S E R V I C E N O T E

OmniBER 37718 / 37719 Comms Performance Analyzer

The following modification is recommended to eliminate potential overheating and premature failure of DS_n DS1 Drop (Demux) Port driver.

DATE: August 2000

Figure 1. Location of Components.

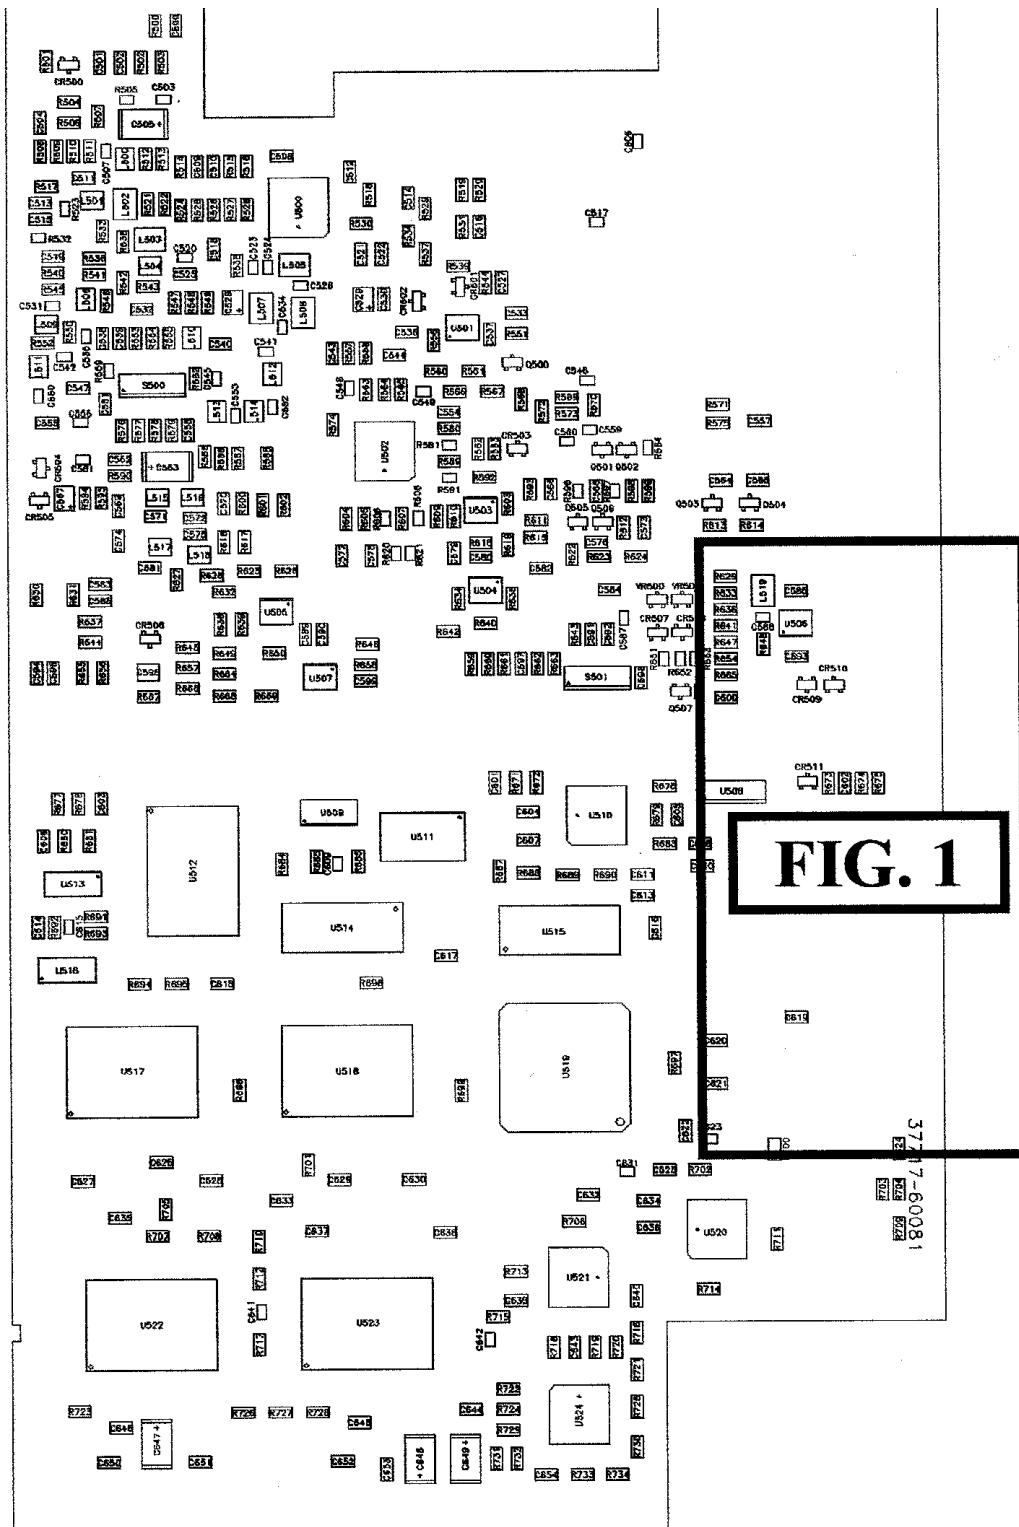
2. Note: Only perform this step if DS_n Drop Port is defective. Remove/replace U505 (PN 1820-8942) taking note of orientation.
3. Solder a 10k ohm resistor Ra (0699-1391) to rh pin of TP8.
4. Solder a 10k ohm resistor Rb (0699-1391) to rh pin of TP8.
5. Add a wire link from vacant end of Ra to U506 pin 1 using insulated wire (see Figures 1 and 2).
6. Add a wire link from vacant end of Rb to U506 pin 7 using insulated wire (see Figures 1 and 2).

Figure 2. Position of Wire Link.

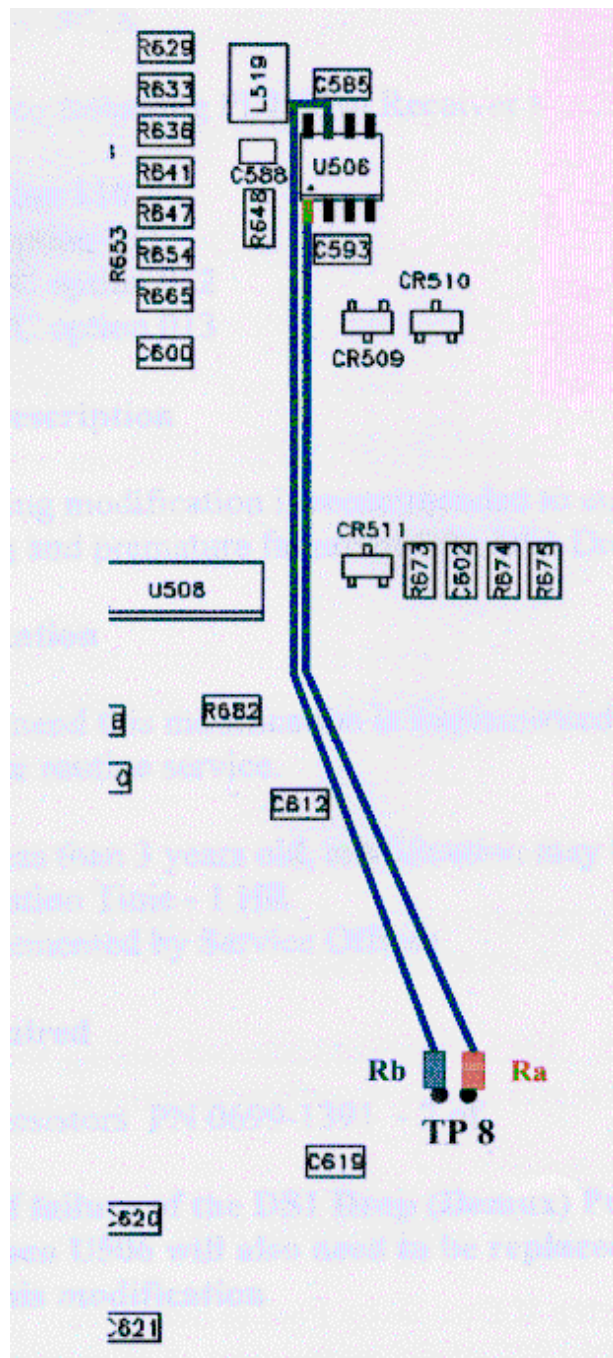
7. Reinforce with epoxy.
8. Refit module and confirm correct operation of the Drop Port as in step 1.
9. Fit a label to the rear of the instrument to indicate that this Service Note has been implemented.
10. Record the modification on CSO for future records.
